**EXHIBIT LIST FOR SUB 2021-002/EA 2021-007
Preliminary Plat of Highland Vineyards**

STAFF REPORT TO THE BENTON COUNTY PLANNING COMMISSION

FILE NO: **SUB 2021-002**
Preliminary Plat of Highland Vineyards

PRELIMINARY PLAT

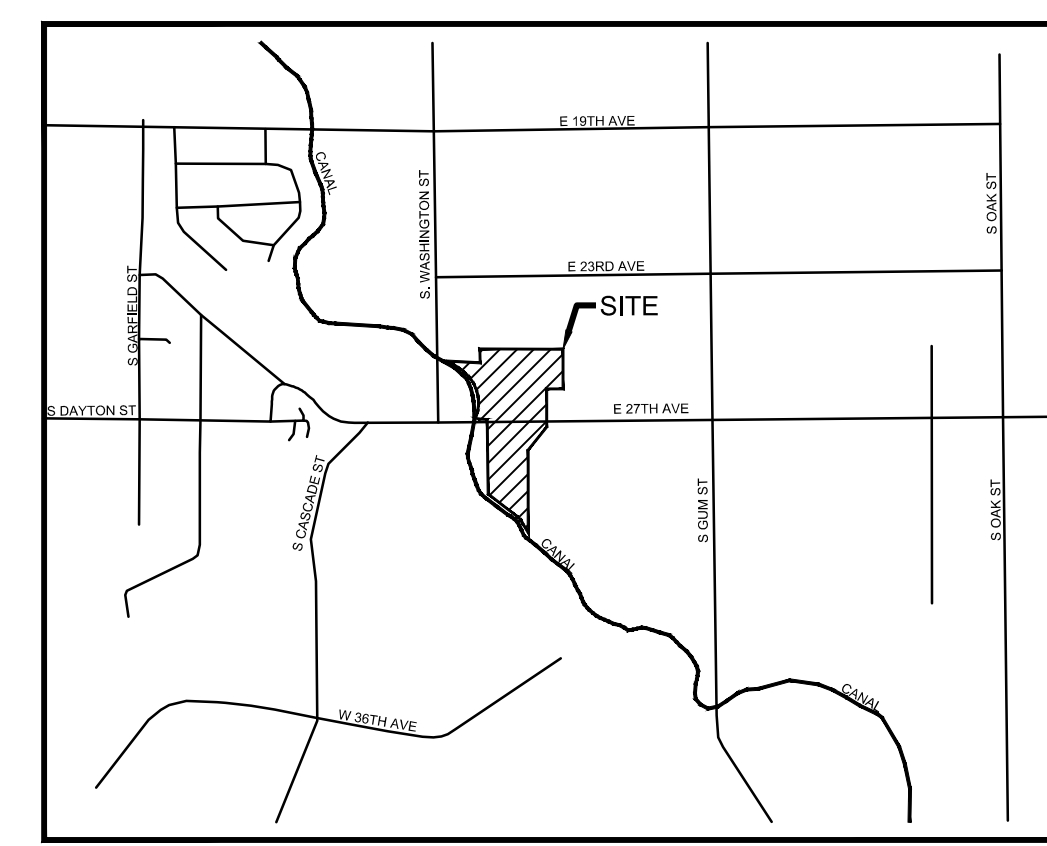
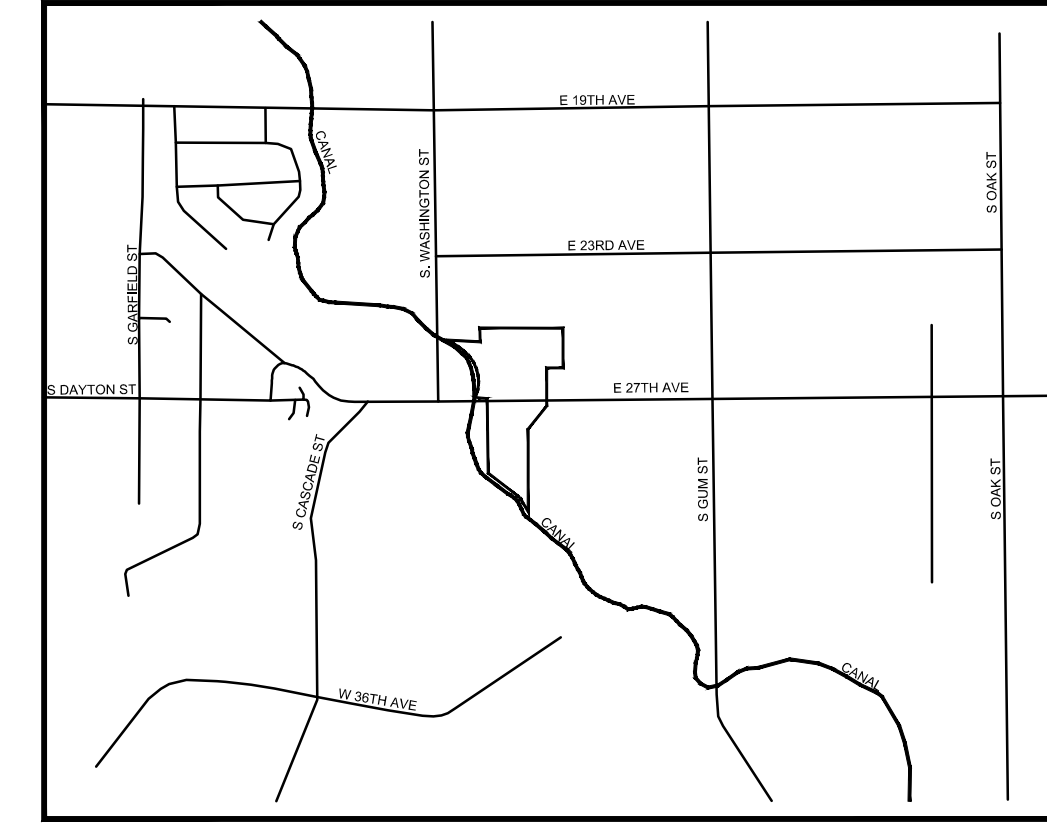
- The 18' Public sidewalk, utility and irrigation easement shall be shown on the preliminary and final plat per City of Kennewick street standards
 - Note 1: Change "RIGHT-OF-WAYS" to RIGHTS-OF-WAY

- Note 2: Change "RIGHT-OF-WAYS" to RIGHTS-OF-WAY. Right-of-way shall be dedicated to the County not City
 - b. Please add the following notes to the plat:

- a. Fire hydrants are to be located, installed, inspected, and approved by the City of Kennewick.
 - b. The locations of the hydrants are not shown on the preliminary plat map. Please show the hydrant locations on the plat map and provide a copy of the agreement to supply services by the City of Kennewick Public Services Department prior to Final Plat Approval.

- c. Show the location, name, right-of-way widths, and type of surfacing of all streets and alleys located within and adjacent to the land to be subdivided on the plat map.

- d. Please show the following canal easement on the final plat: AF# 92-20893.
- e. Indicate any areas within the plat having a slope of fifteen (15) percent or greater.

- f. Please remove references to the adjacent parcel owner names on the final plat map.
- g. The following notes shall be placed on the final plat:
- “During construction on each property, all construction debris shall be maintained on-site and properly disposed of. Dust control measures including an adequate water supply shall be provided”.

PRELIMINARY UTILITY PLAN

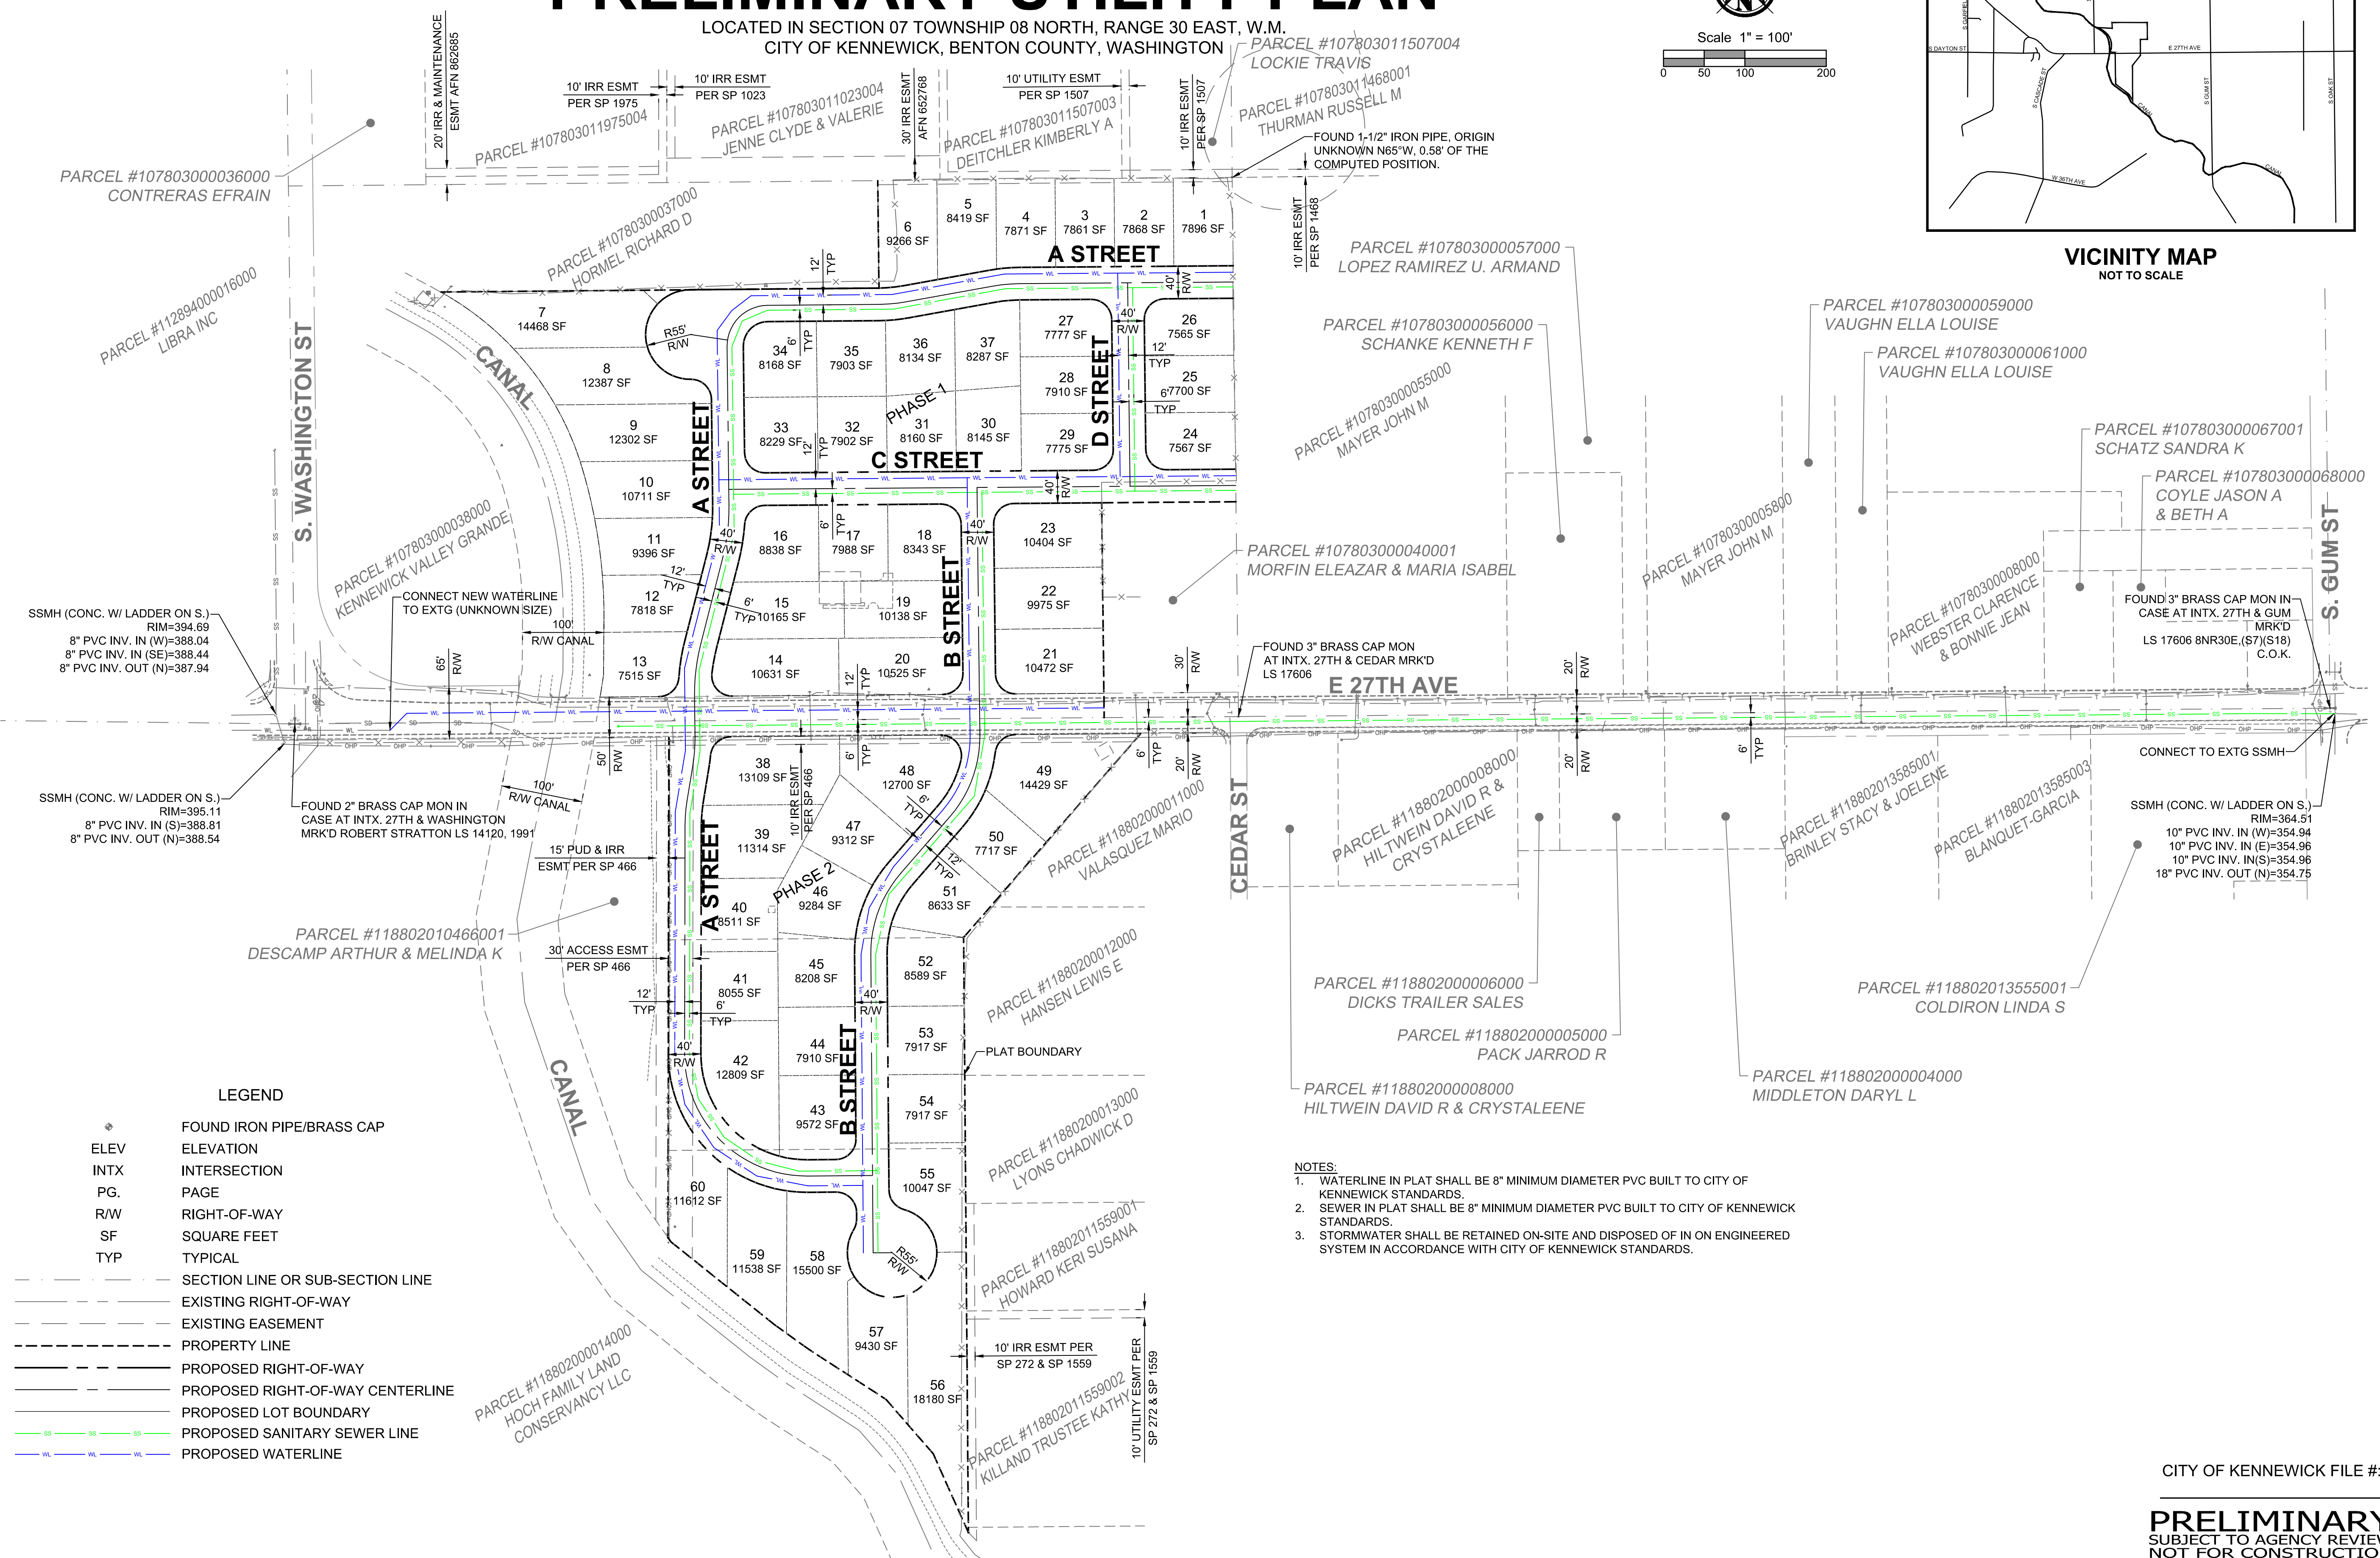
- bb. Provide a water and sewer service to each proposed lot prior to final plat approval per KMC 17.10.080. Developer is required to submit civil drawings with the water and sanitary sewer design for City review and approval to issue a Public Works permit.

- cc. There is an existing 12-inch waterline on the west side of Columbia Irrigation District Canal to serve the proposed development installed with COK Drawing number C2383_12.

- ee. Hydraulic analysis required to model proposed water main system for the site. Developer's engineer to provide their utility layout as well as any phasing plan. COK will submit to RH2 for scope and pricing and the developer will need to approve of the cost as they will reimburse the City

- ff. Provide water lines as required by Fire Department to meet fire protection to meet City of Kennewick Standards on Fire Hydrant spacing per City detail 1-3.

- gg. Hydrants will be required at each intersection, and average spacing of 500' between hydrants. KFD will have final approval as to location and number per attached plan.

- ii. There is an existing 8-inch sanitary sewer line stubbed west from sanitary sewer manhole located at the street intersection of E 27th Ave and S Gum St installed with COK Drawing number C4005_12.

- kk. Each lot requires its own 4" connection to the city sewer system per KMC 14.22.030(10).
 - ll. When preparing civil drawings to connect or extend water and sewer services, all plans showing existing utilities shall call out the Record Drawing set number that installed the utilities. All plans need to clearly identify the size and type of water/sewer utility that is being proposed or connected to (i.e. "Existing 8-inch Water" or similar). Label private lines "Private".

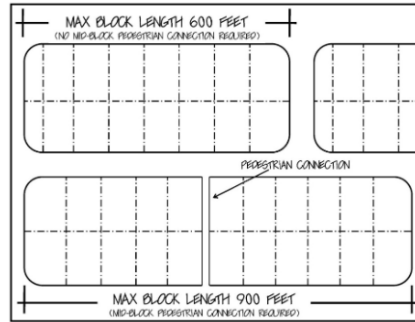
1. Provide a trip generation and distribution analysis letter. The proposed development will exceed the trip threshold limits > 30 new peak trips. Recommend the traffic consultant to contact the city’s Traffic Engineer prior to the start of the analysis to discuss the trip generation rates and distribution pattern used for the analysis.

Development Level	Trip Generation ^(a)	Analysis Requirement
Level 1	≤ 30 peak hour trips	None
Level 2	>30 < 100 new peak hour trips	Trip Generation and Distribution Letter
Level 3 ^(b)	≥ 100 new peak hour trips	Traffic Impact Analysis (TIA) Study

Proposed Driveway(s)

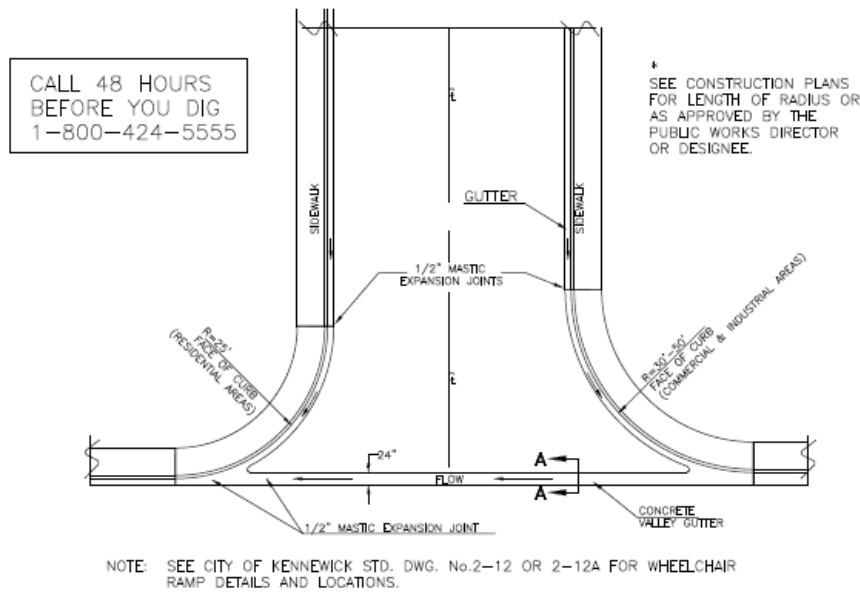
1. Effective 11/4/19, Residential driveways: Any lot may have a maximum driveway width of 36-ft (bottom width) – as long as it can meet the ADA requirement of a minimum 5-ft flat landing between driveways. Driveway widths are **NO** longer associated with garage/RV bays.
2. Residential driveways: The minimum 1:1 widening taper from the back of sidewalk, for widening out the driveway (behind the sidewalk) to greater than 36-ft wide, is required.
3. Please note that City roadways have to meet minimum centerline horizontal radius requirements per KMC 5.56.275(1). See below.

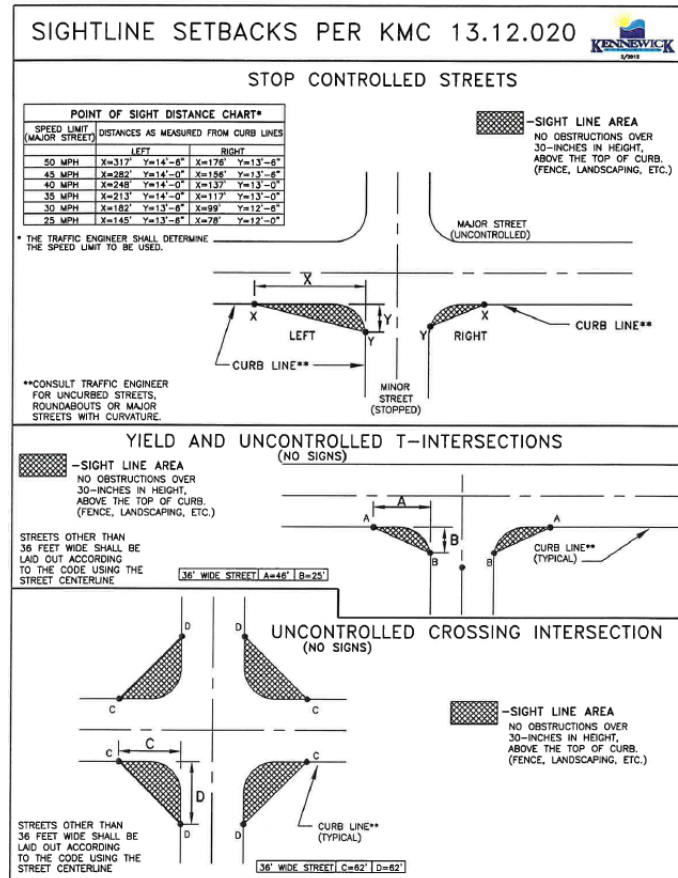
6. Street - Sightline setback triangles per KMC 13.12.020(5) are required with no view obstruction permitted between 36 inches and 90 inches above the roadway surface for both sides of the setback triangles, except as allowed in Section 13.12.020(6).

KMC 17.20.010(3)(l)

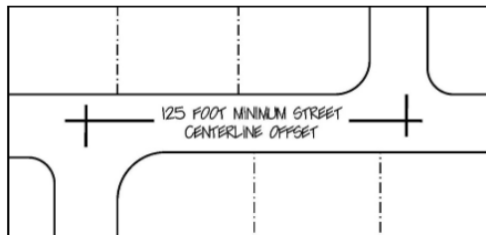
7. KMC 17.20.010(4)(d) – Lots shall not have direct driveway access onto arterial or collector streets unless approved by the Traffic Engineer.
8. The proposed street intersection spacing between the two proposed subdivision roads of E. 27th Ave does not appear to meet the minimum centerline offset of 300' per KMC 17.20.010(3)(l). See below.
 - (l) Residential streets shall be aligned at the centerline or be offset a minimum of 125 feet while intersections with arterial or collector streets shall have a minimum centerline offset of 300 feet, unless specifically waived by the City Traffic Engineer;
